ADDENDUM NO. 3
TO THE CONTRACT DOCUMENTS

Date: May 14, 2021
Jacobs Project No.: D3403200

for the
Crestview WWTP Solids Handling Improvements

JACOBS
BUILDING MECHANICAL
**DEWATERING BUILDING
FLOOR PLAN**

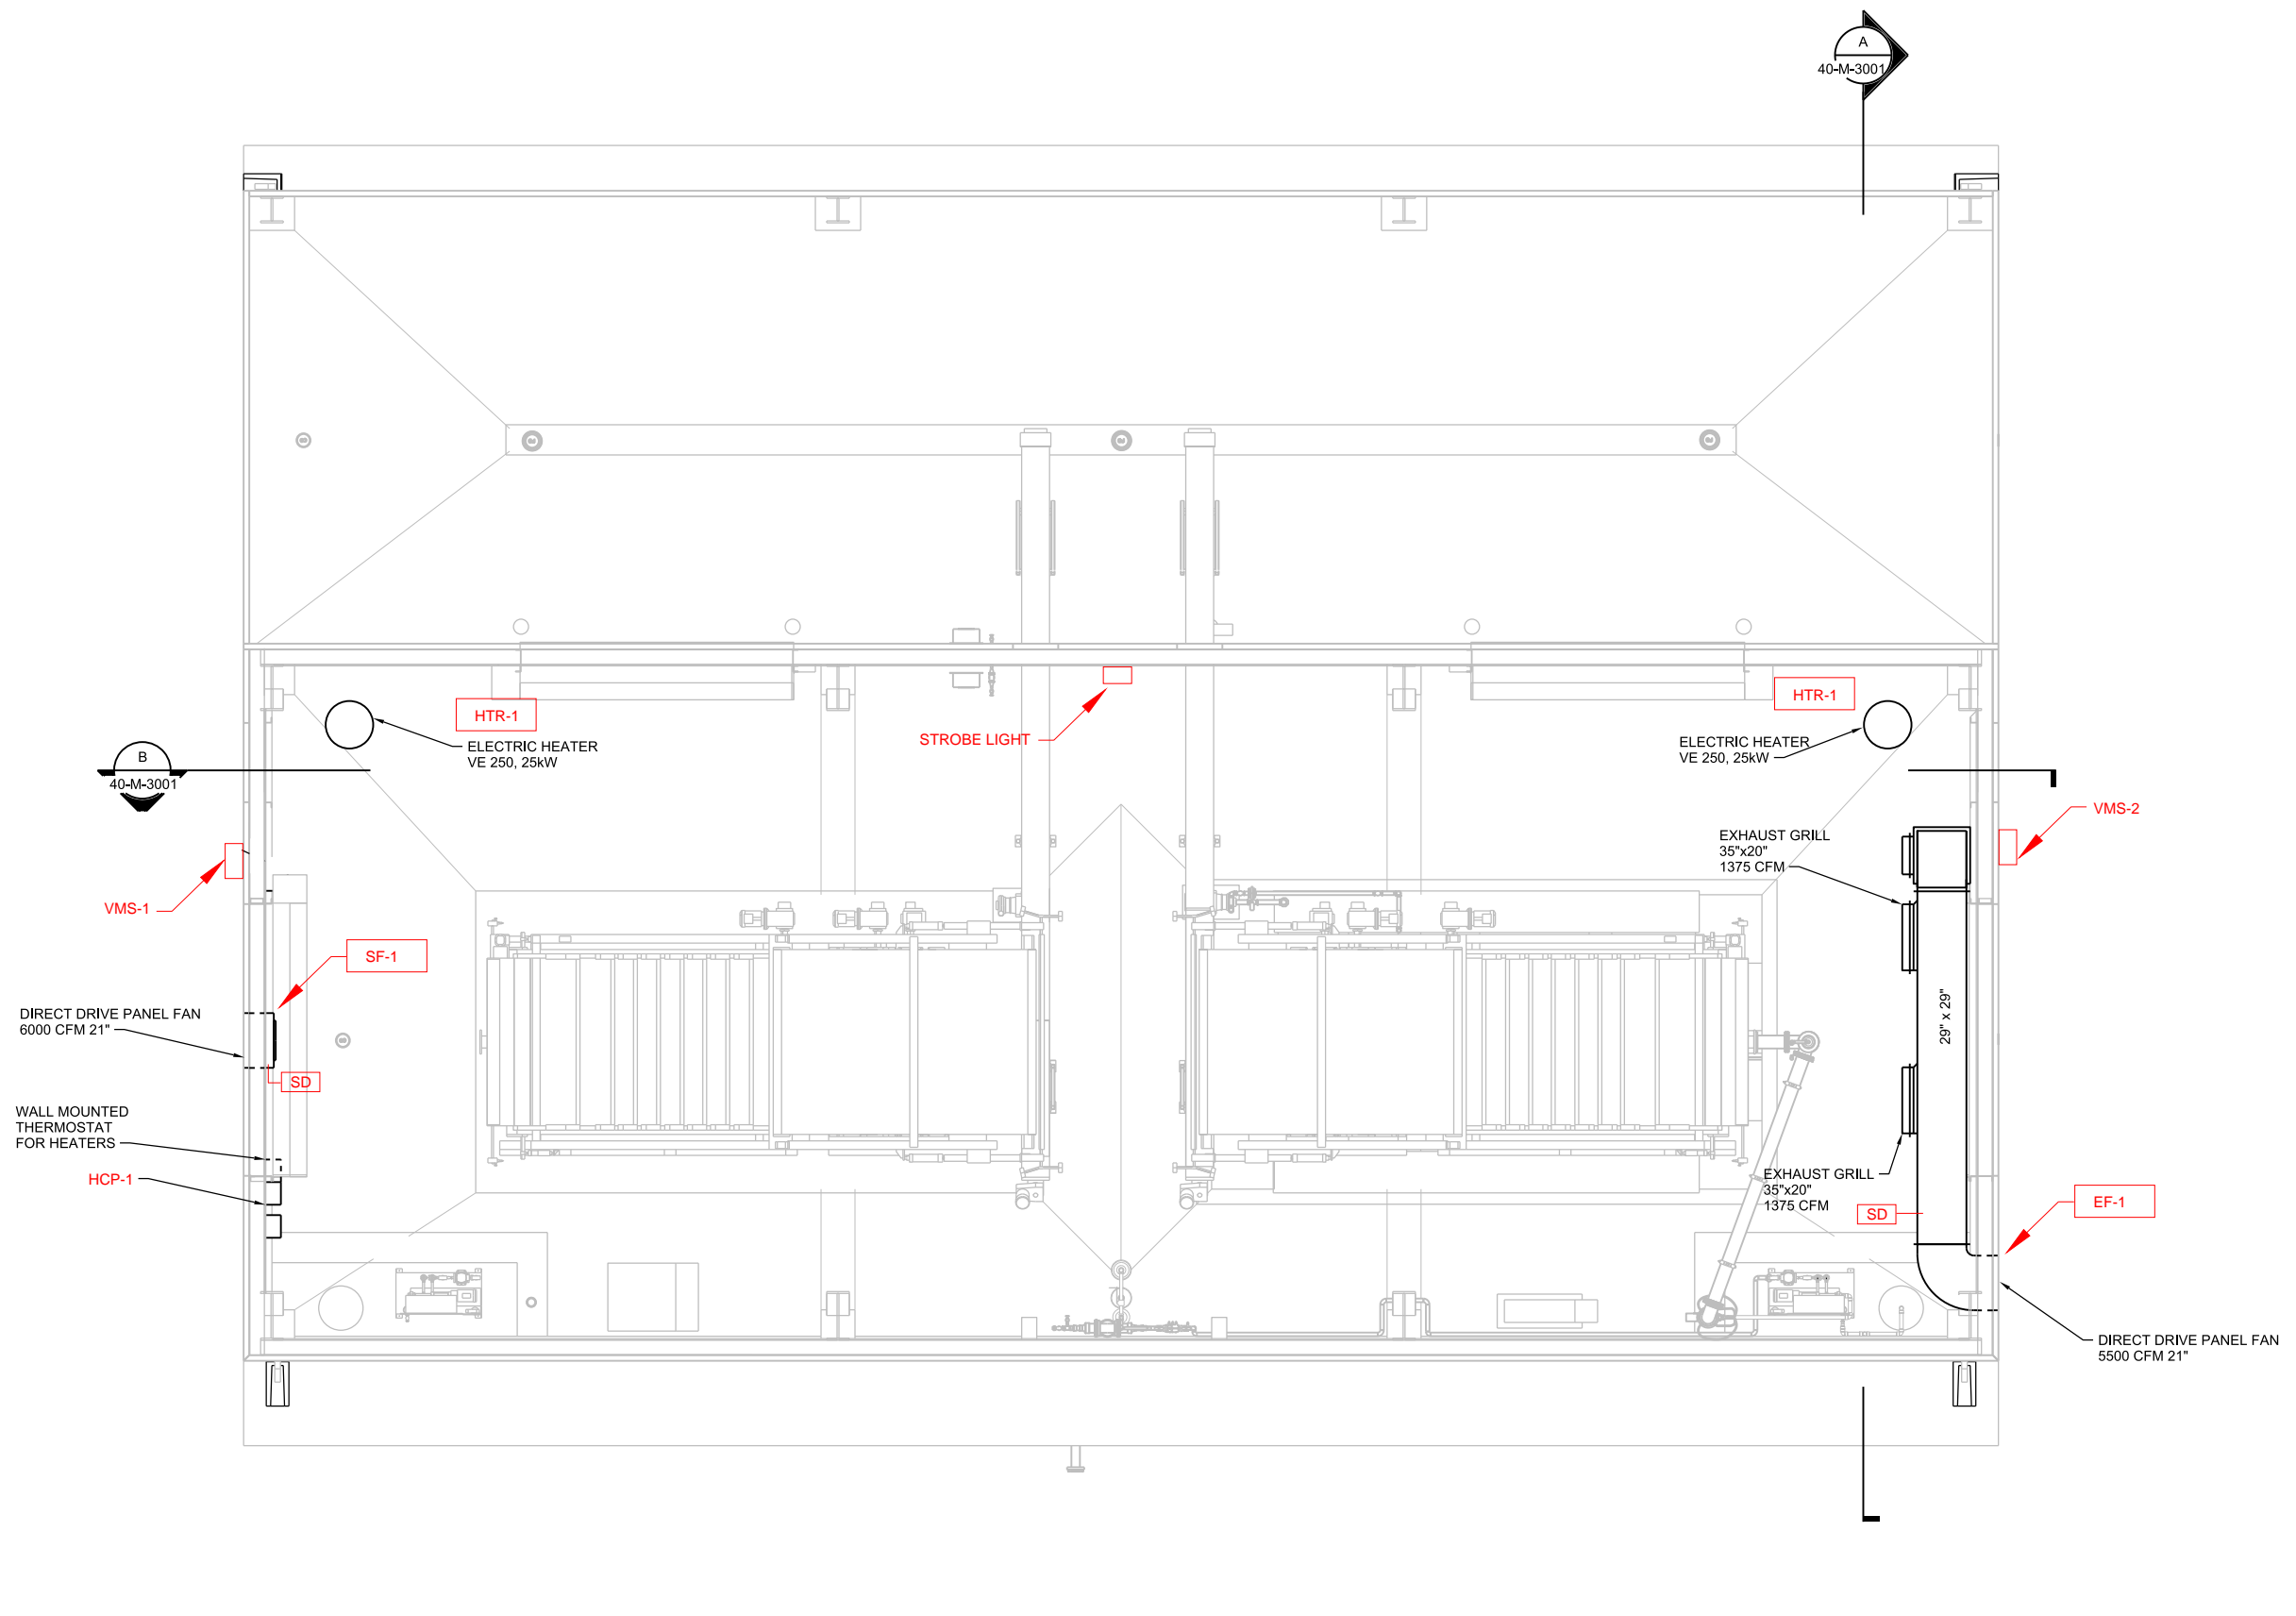
1. Drawing 40-M-2001, INCORPORATE the attached Drawing 40-M-2001 markups.
2. Drawing 40-M-3001, INCORPORATE the attached Drawing 40-M-3001 markups.
